Town of Medway
DESIGN REVIEW COMMITTEE
155 Village Street, Medway MA 02053
(508) 533-3291

DRC Meeting Minutes: June 04, 2018 Medway Public Library

Design Review for 9 Trotter Drive site plan for Converting Technical Services

CHOATE PARK CHANGEABLE MESSAGE SIGN

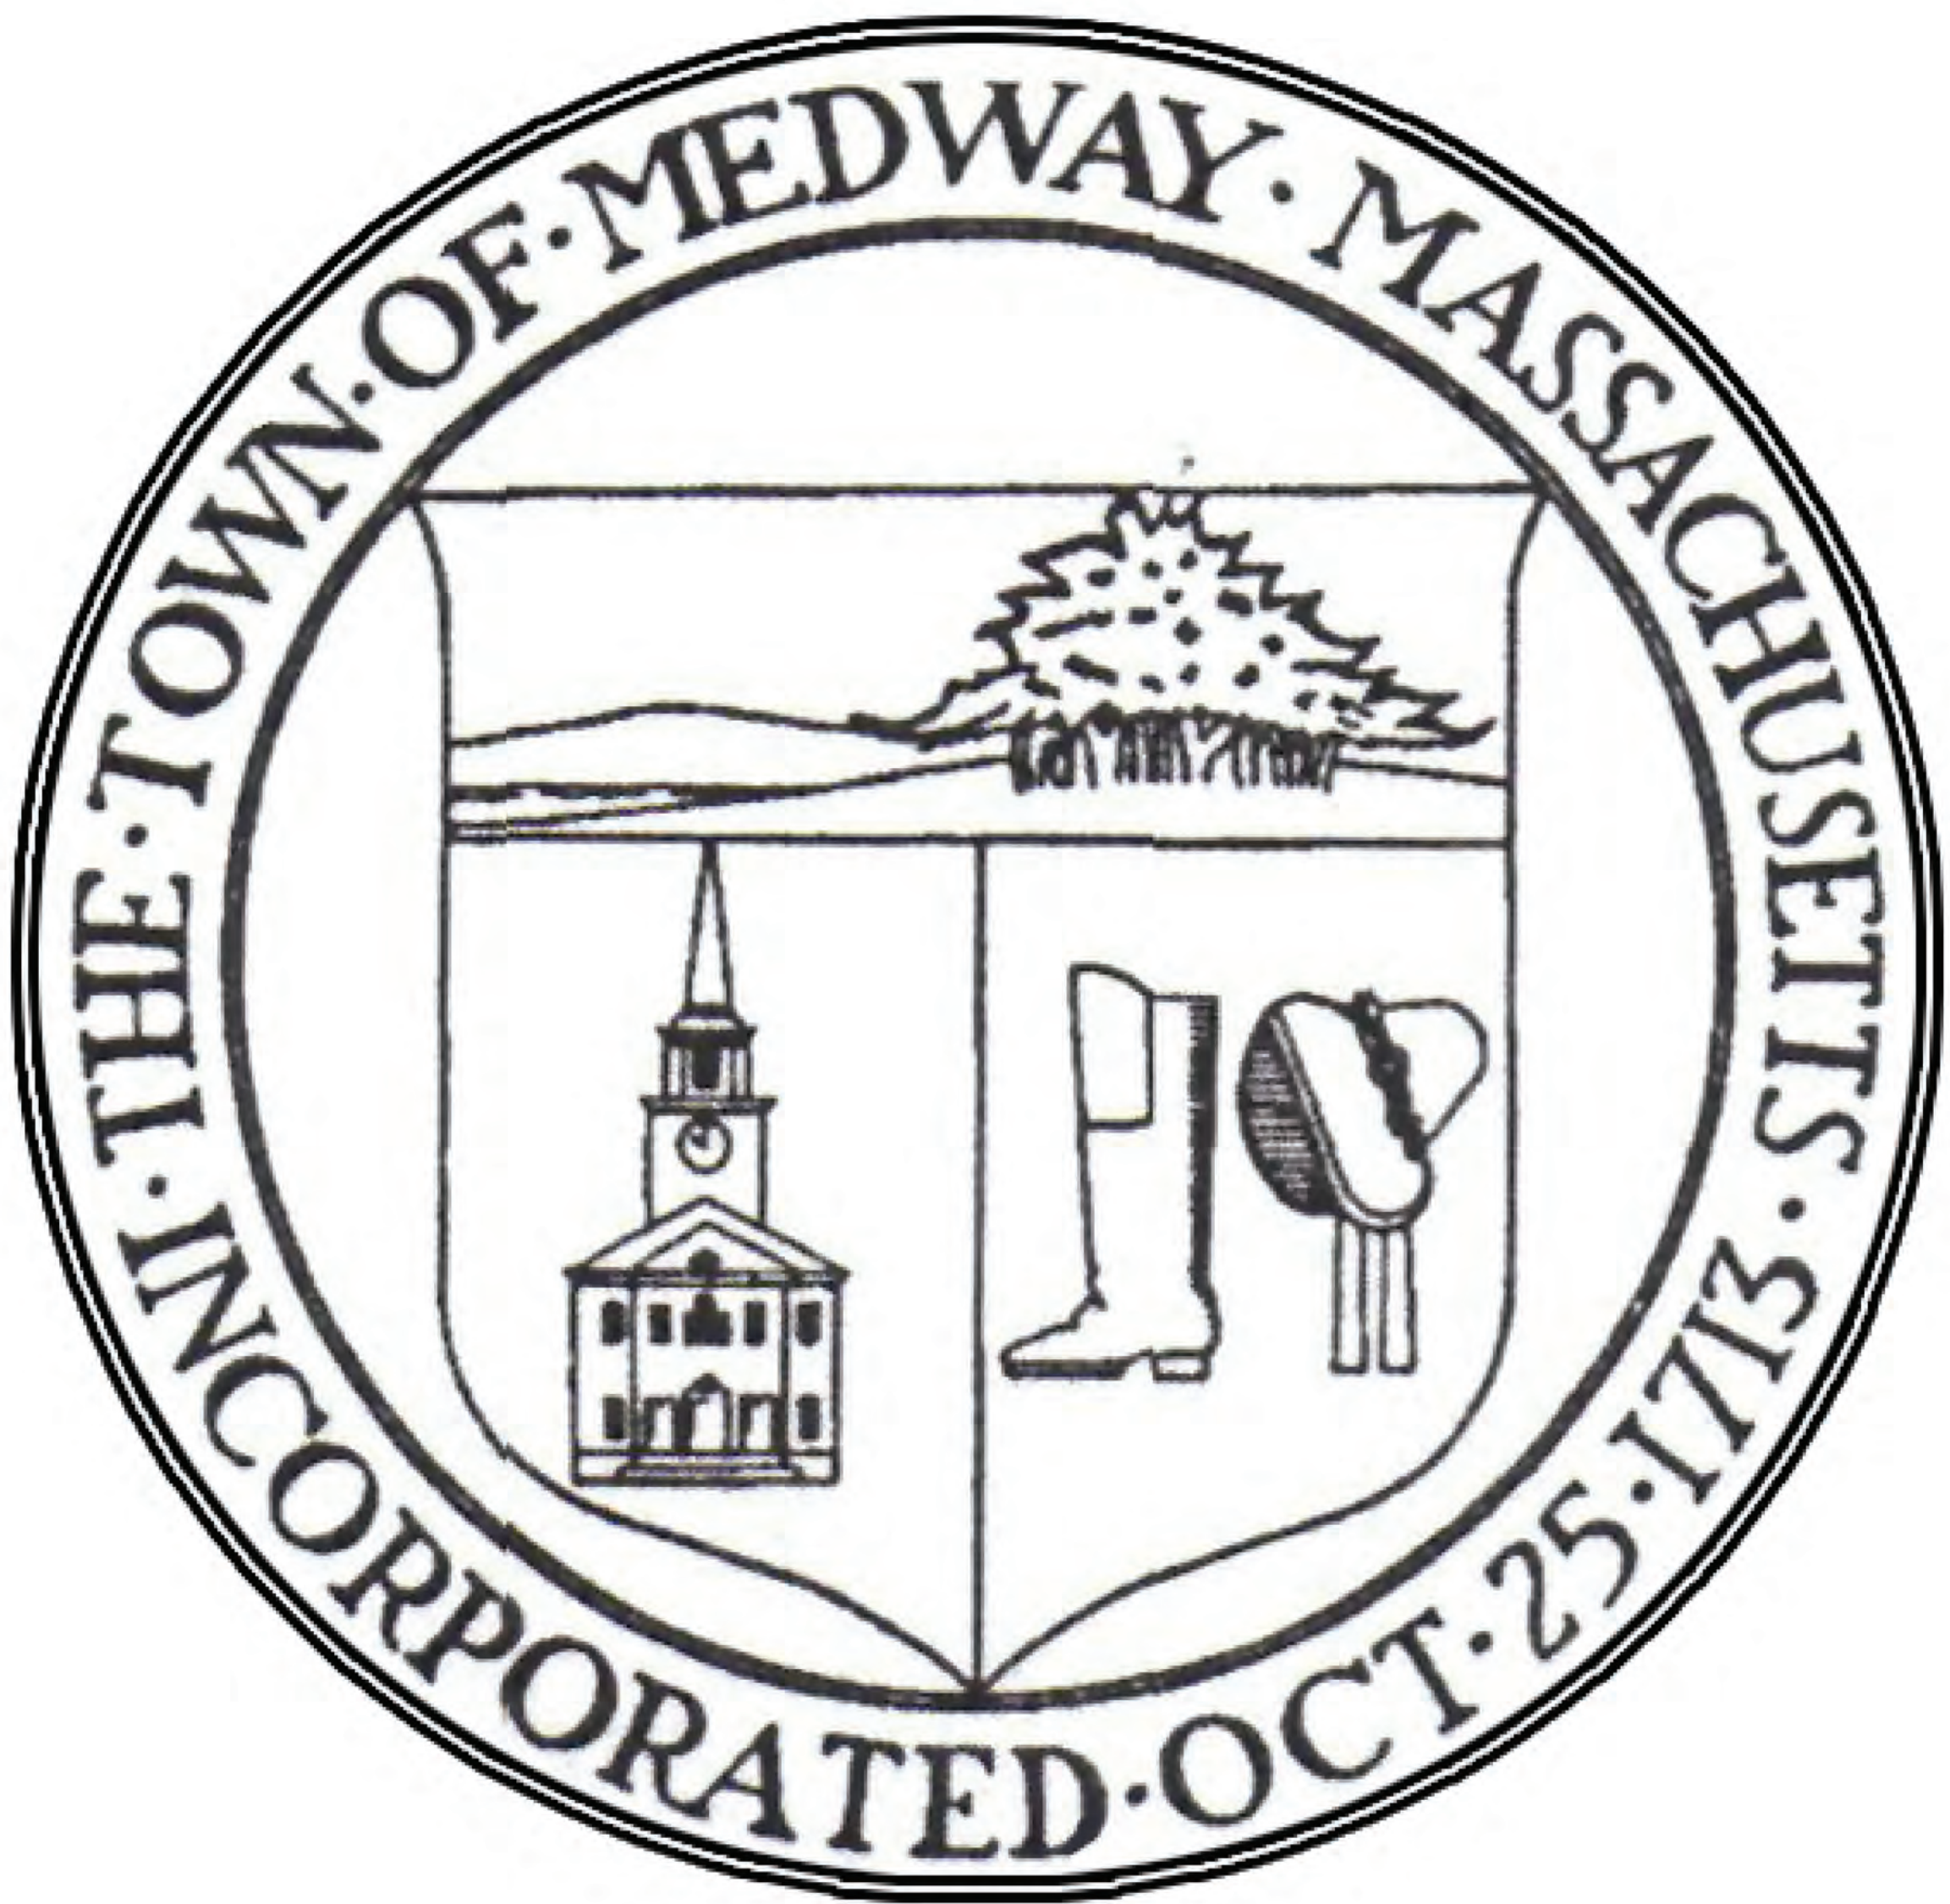
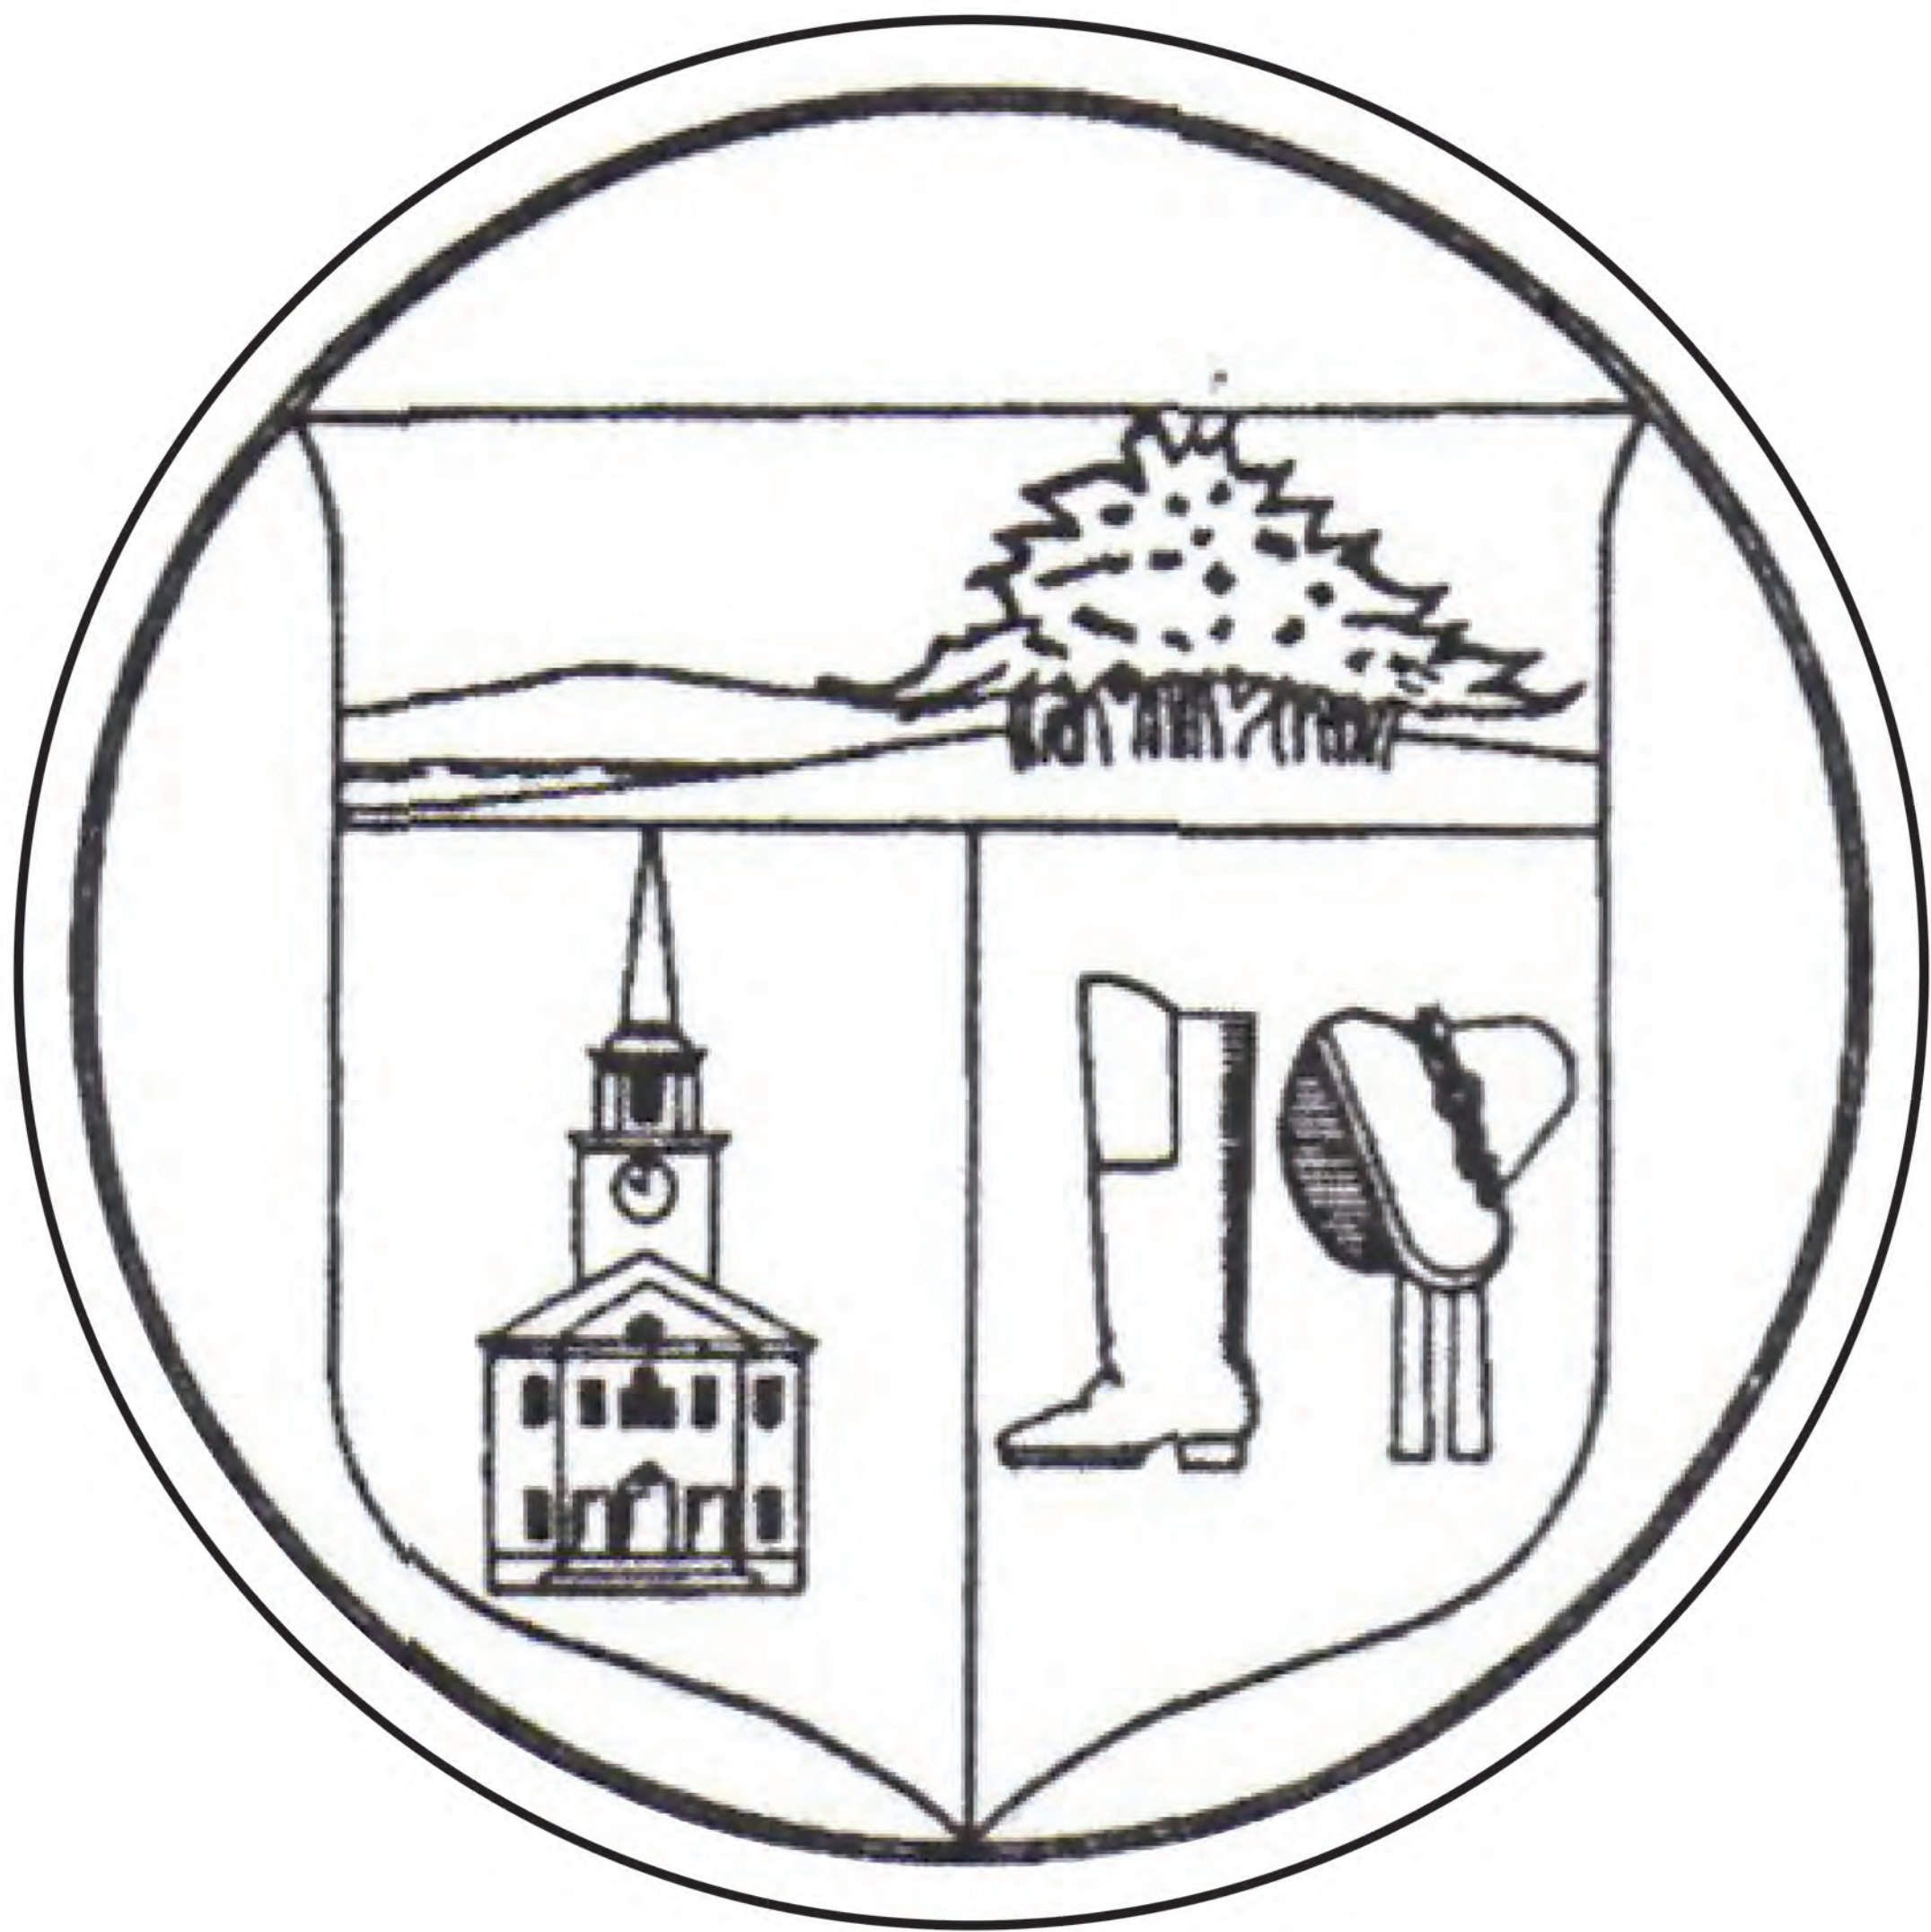
- ❖ Ms. Affleck-Childs distributed the granite bollard draft concepts submitted by DJ Chagnon from CBA. (**See Attached**) There was some discussion on the location of the way finding signs. Ms. Affleck-Childs said EPFRAC will be meeting on June 11th. Mr. Buckley will be reaching out to EPFRAC Chair Rick D’Innocenzo to discuss the location (s) of the way finding signs and the bollards. Perhaps the bollards can be eliminated as the community message board sign includes Choate Park inset signs.

- ❖ Way finding sign on the Cassidy side of Choate Park were discussed as an option.
- ❖ DRC members quickly reviewed the “Town of Medway” concepts shared by DJ Chagnon.
